TO: Mike Schulze, Cobblestone Denver
FROM: Stacey Nerger, Senior Planner
DATE: May 26, 2025
SUBJECT: Parker and Pine Filing No. 1 Lot 4 – Site Plan Amendment
Review Comments 02

Staff Comments 02
SP25-018; Parker and Pine F1 L4
Site Plan Amendment
May 26, 2025

PARKER AND PINE FILING NO.1 LOT 4 - CAR WASH

SHEET TITLE
EXTERIOR ELEVATIONS

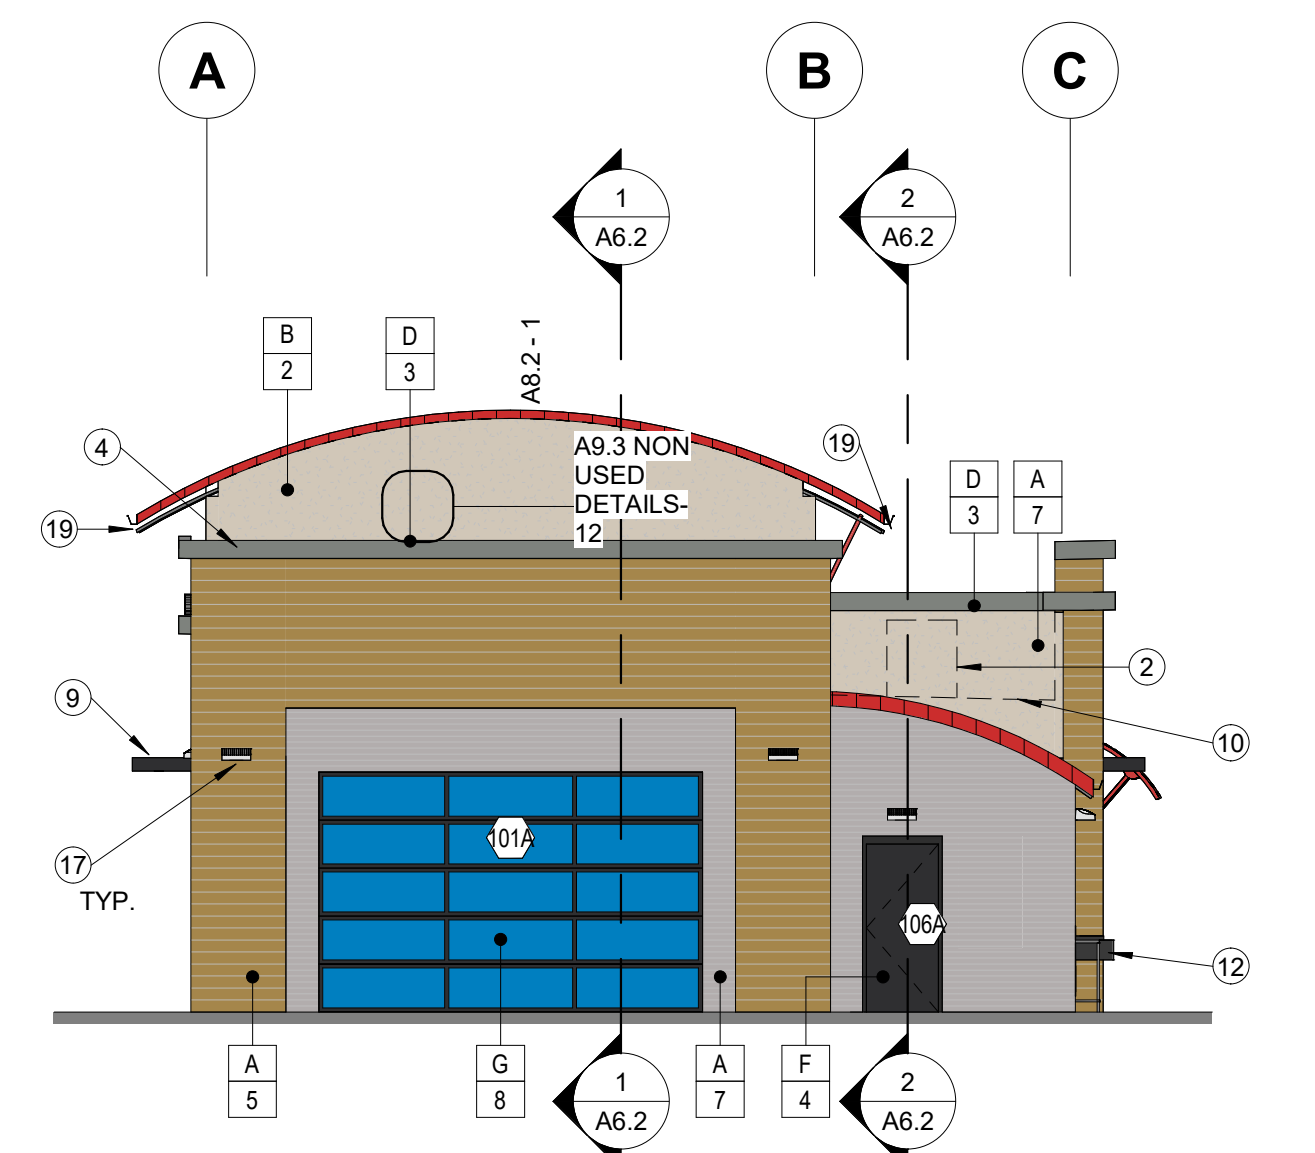
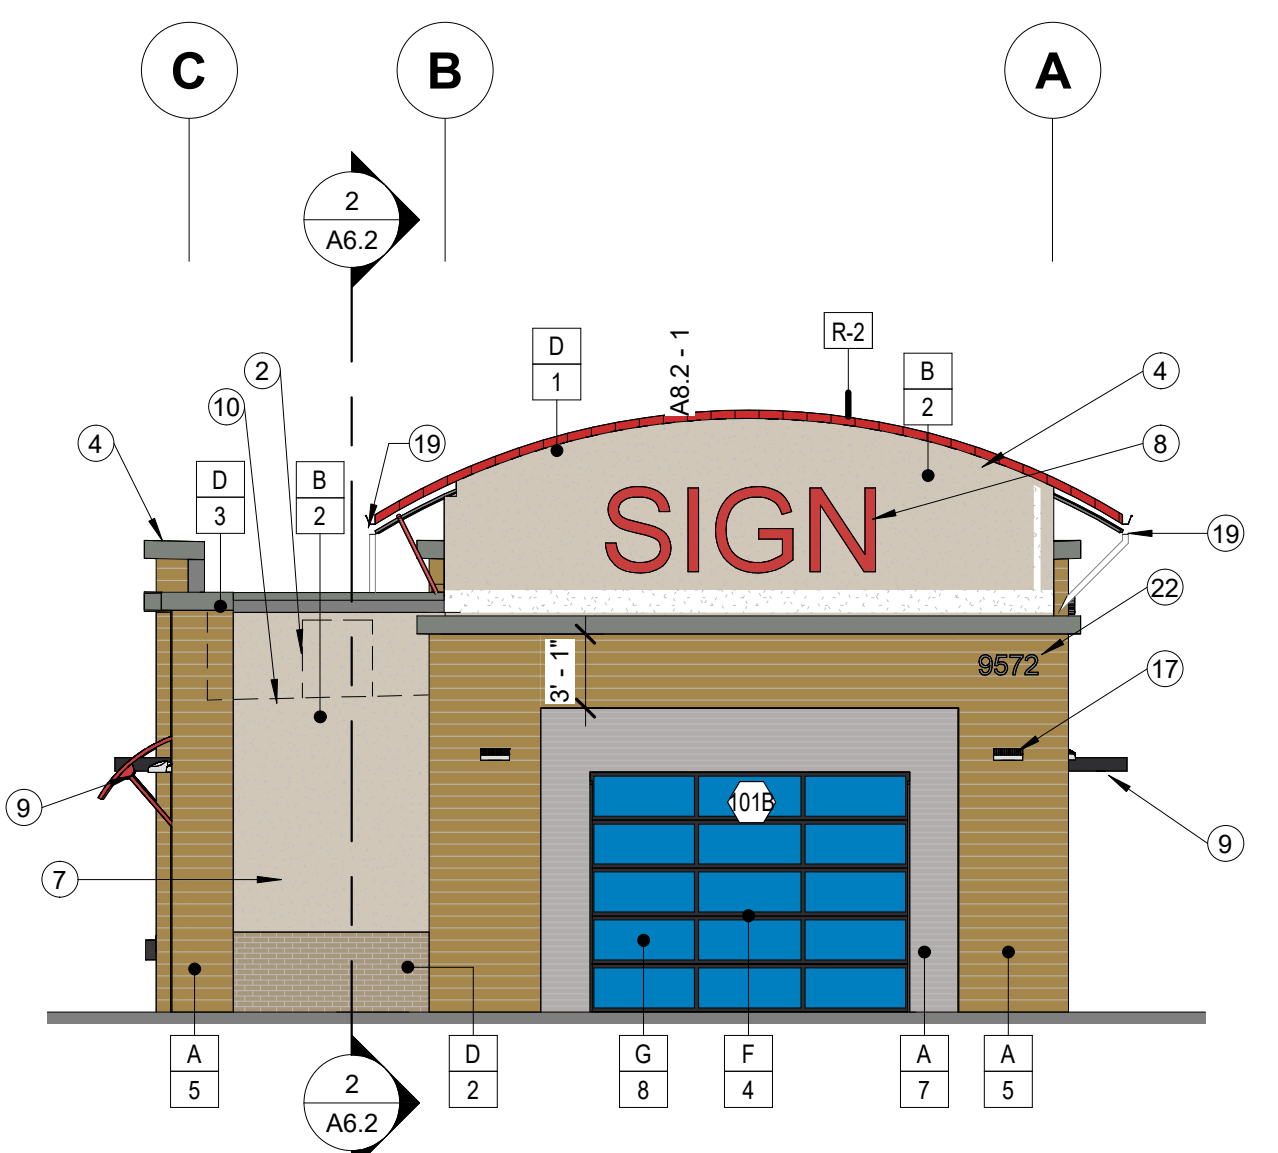
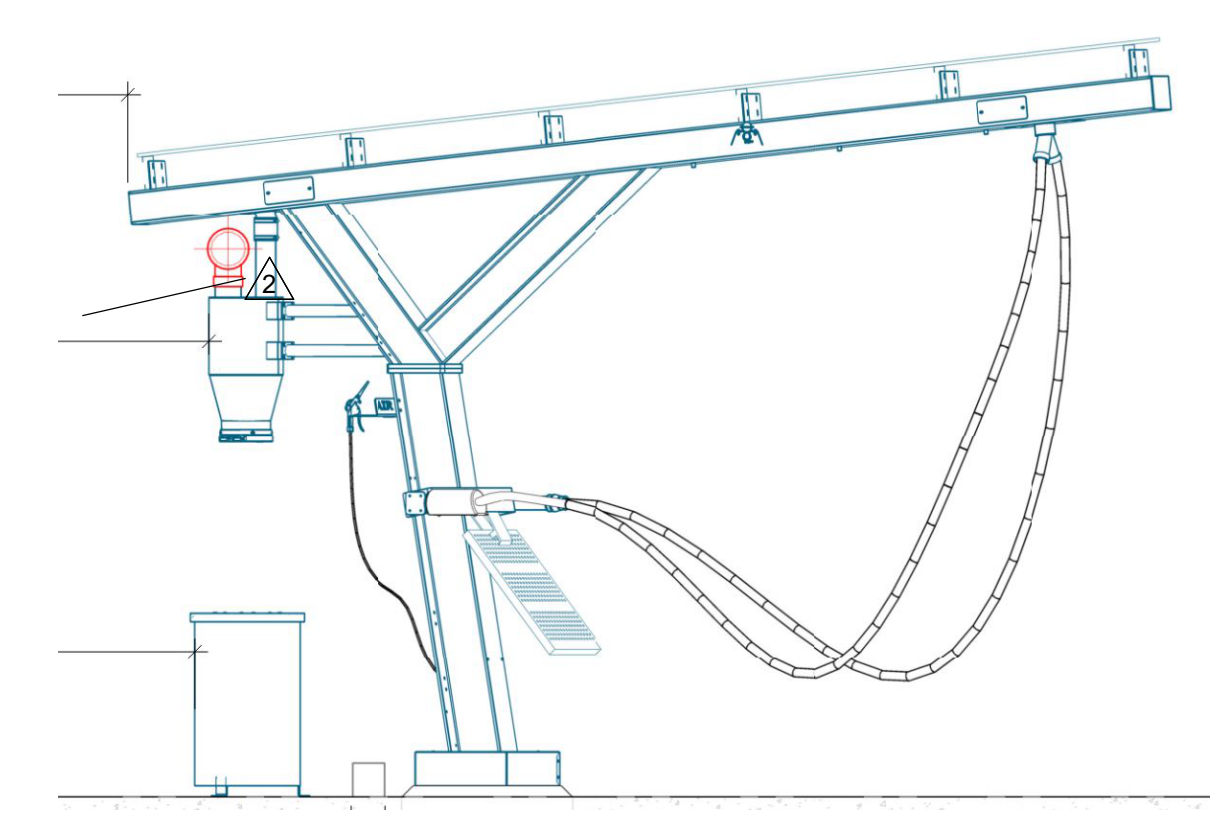
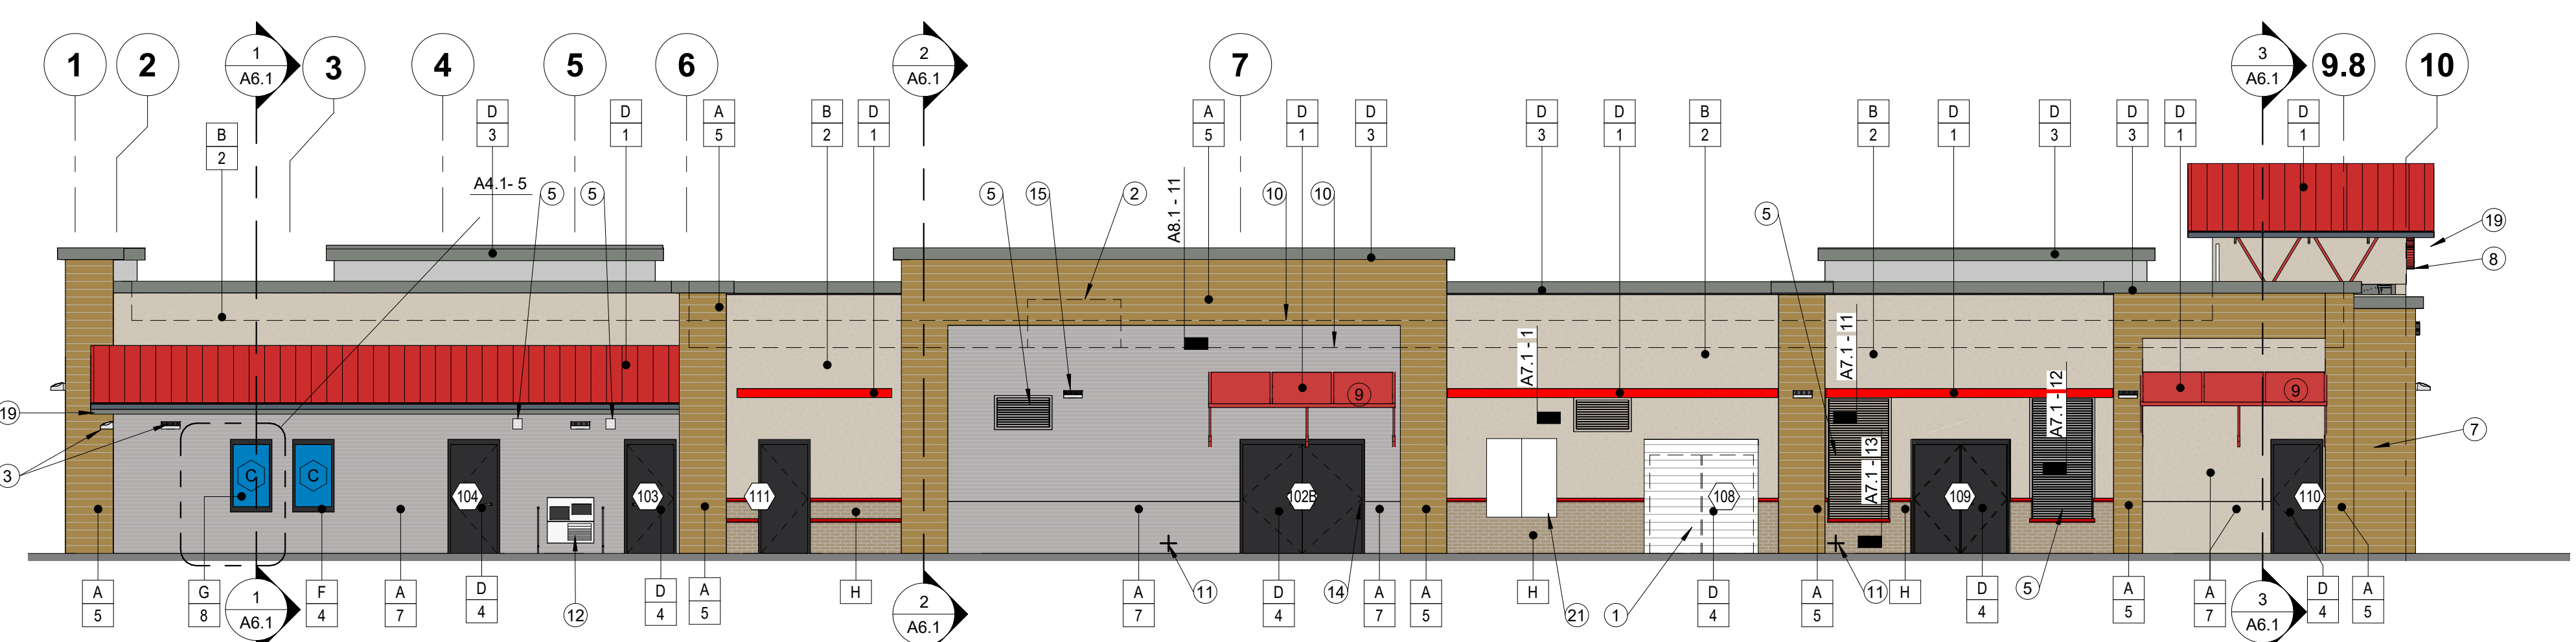
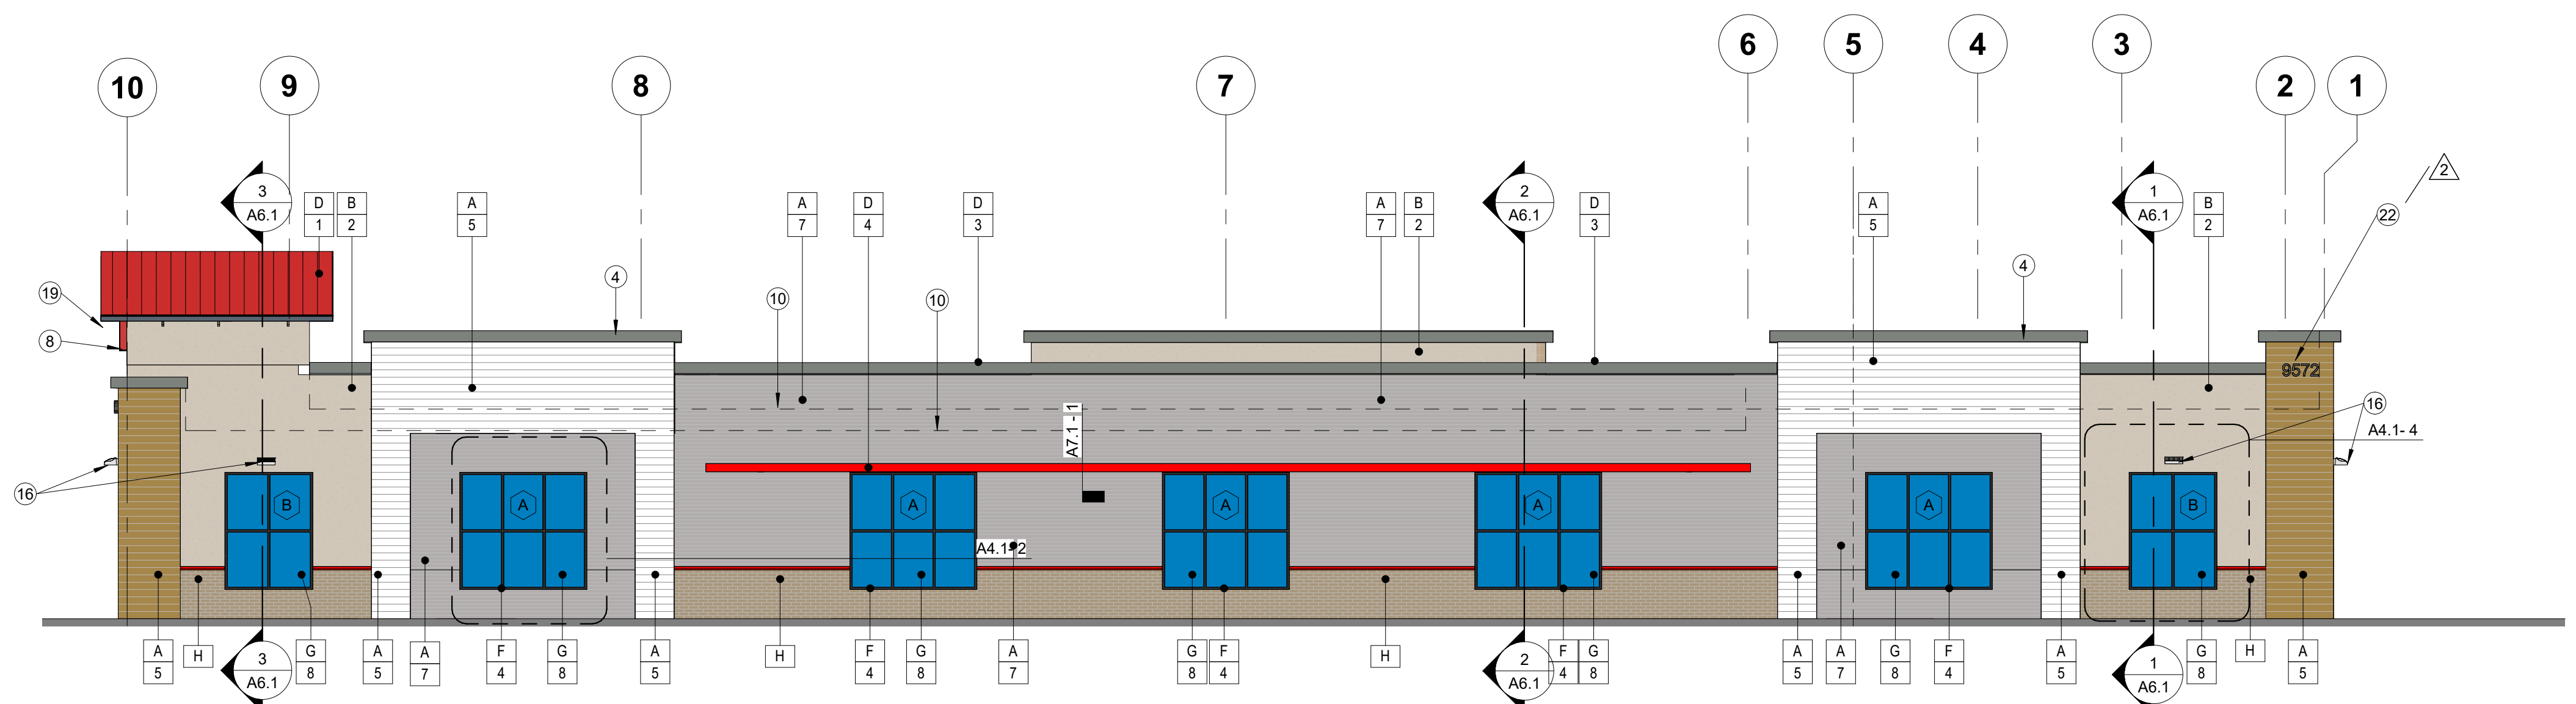
Following images needed:
 1. Please include the trash enclosure elevations sheet.
 2. Bollards with colors
 3. Pay stations with colors
 4. Stop bars with colors
 5. Bicycle rack with colors
 6. Vacuum equipment artwork/wrap
 7. Any other exterior elements that have not yet been mentioned.

SHEET TITLE
**PHOTOMETRIC
 SITE PLAN**

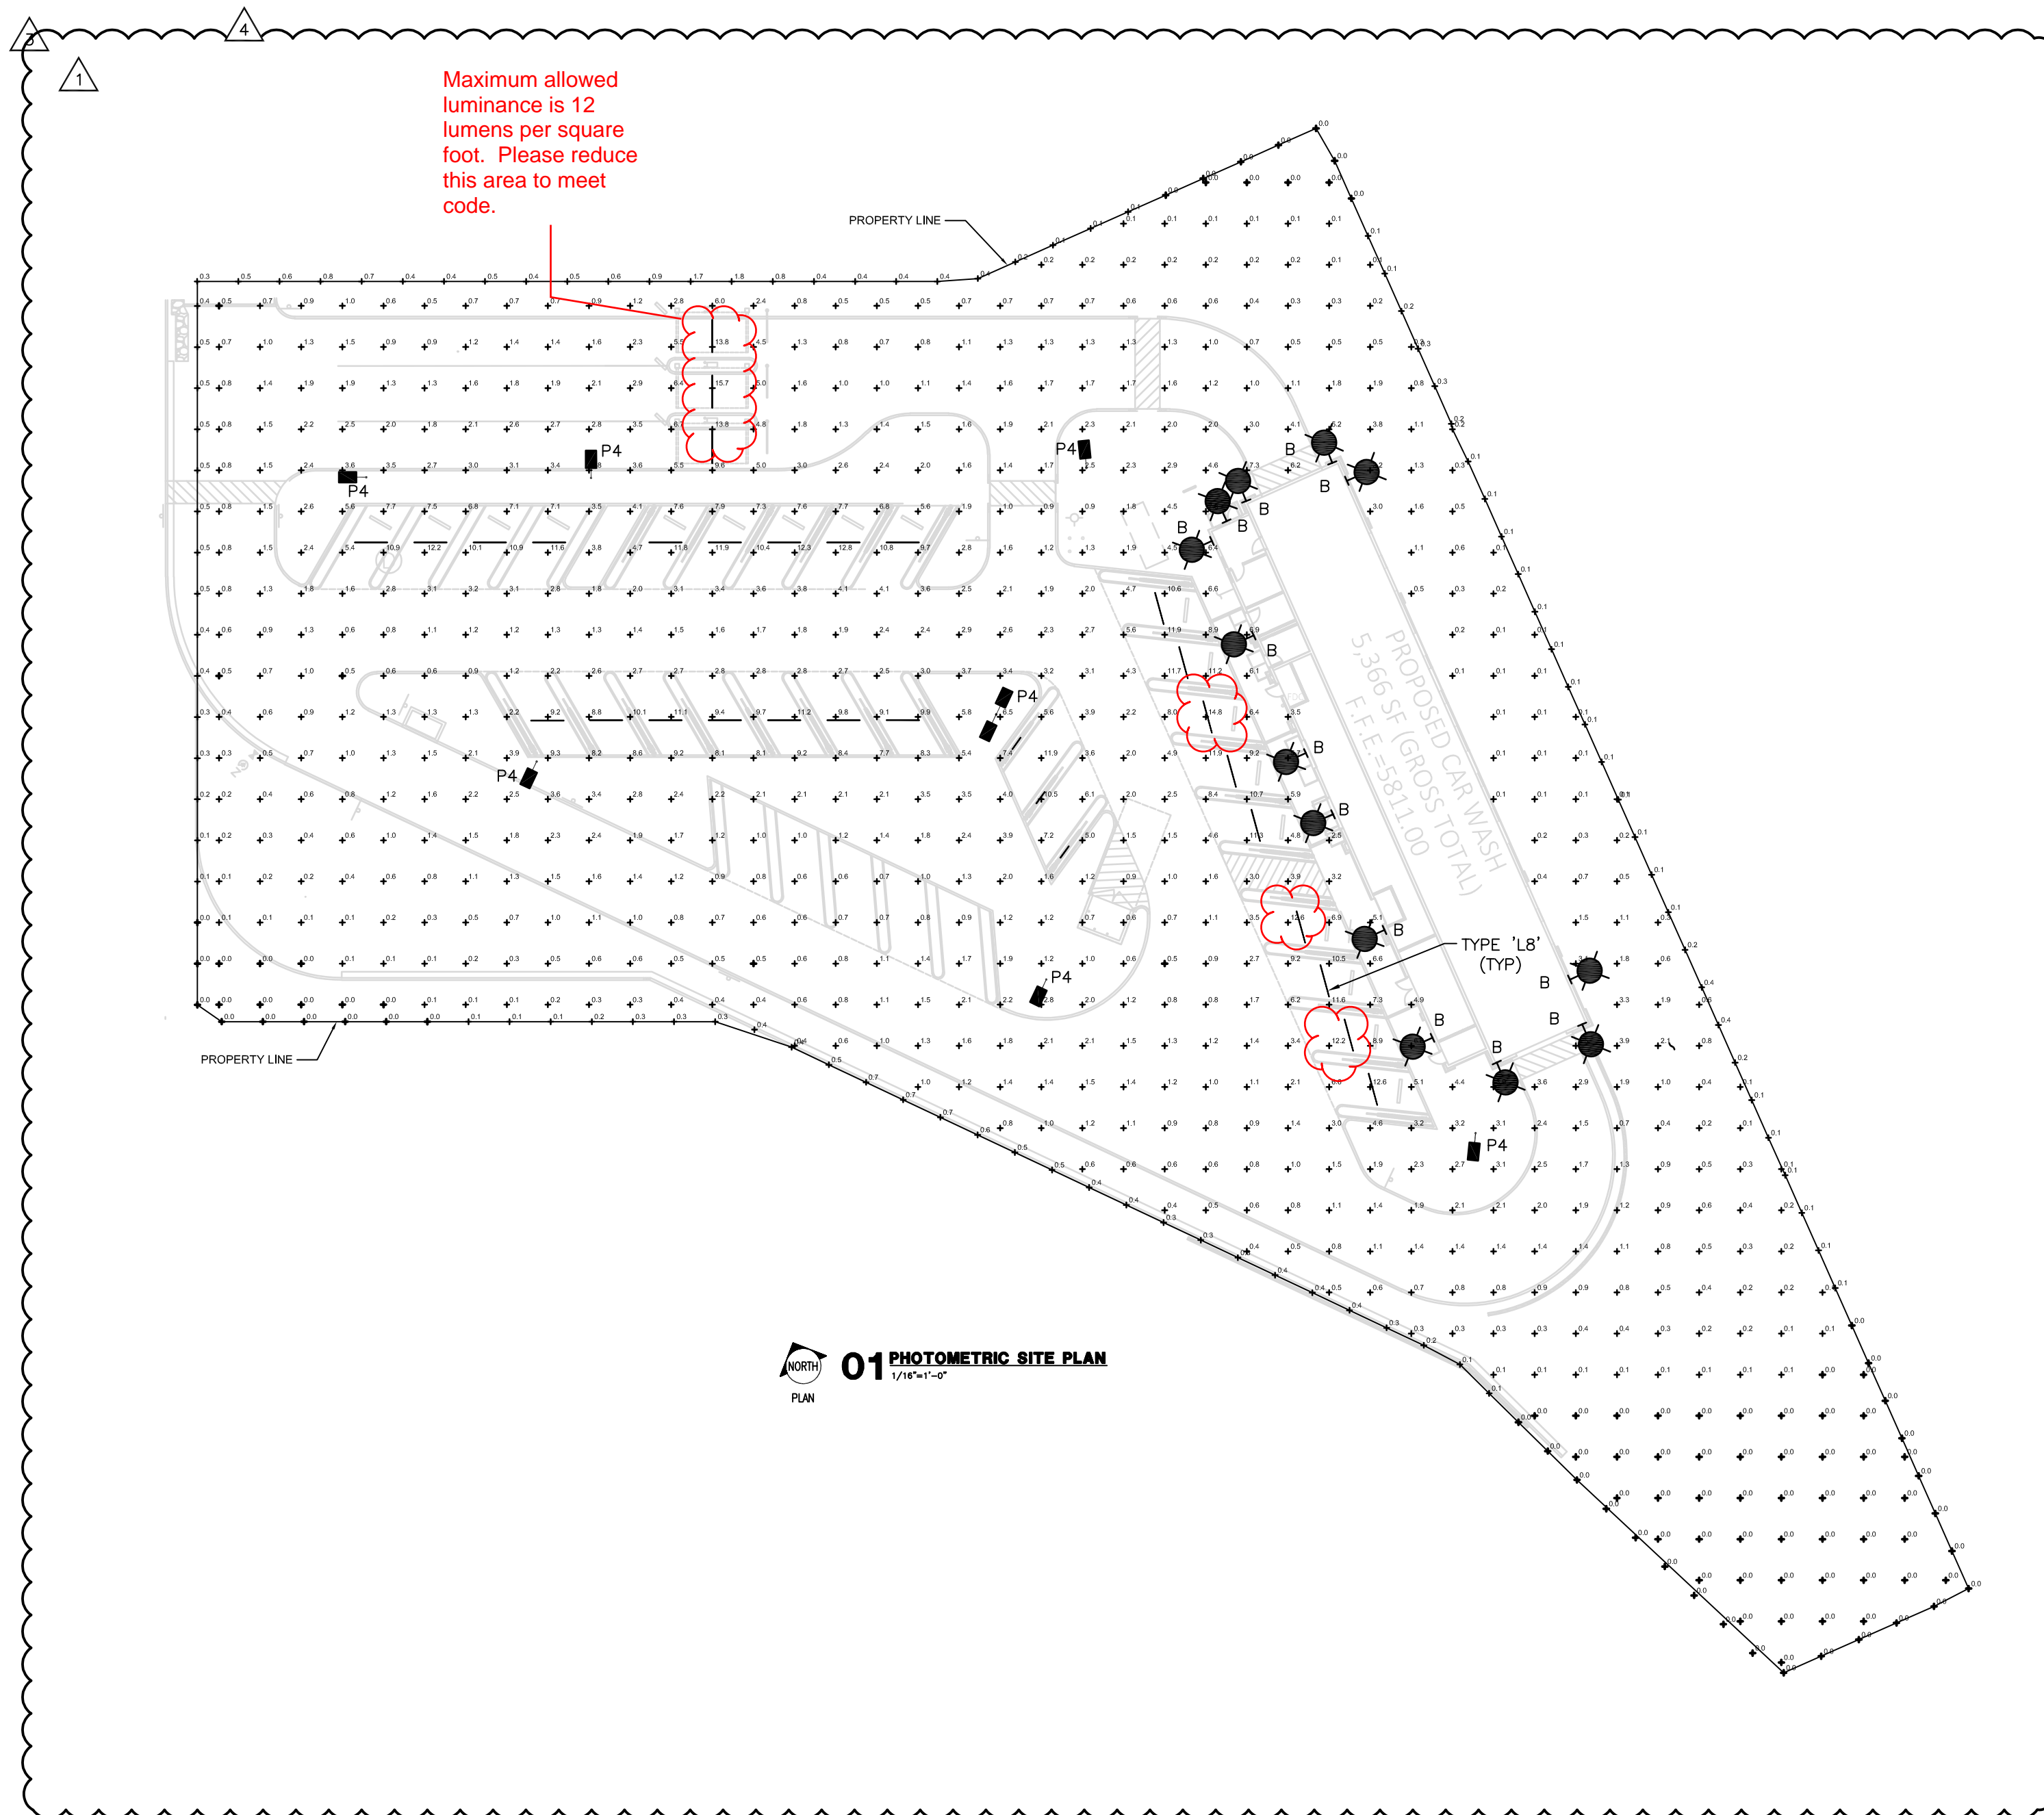
Maximum allowed luminance is 12 lumens per square foot. Please reduce this area to meet code.
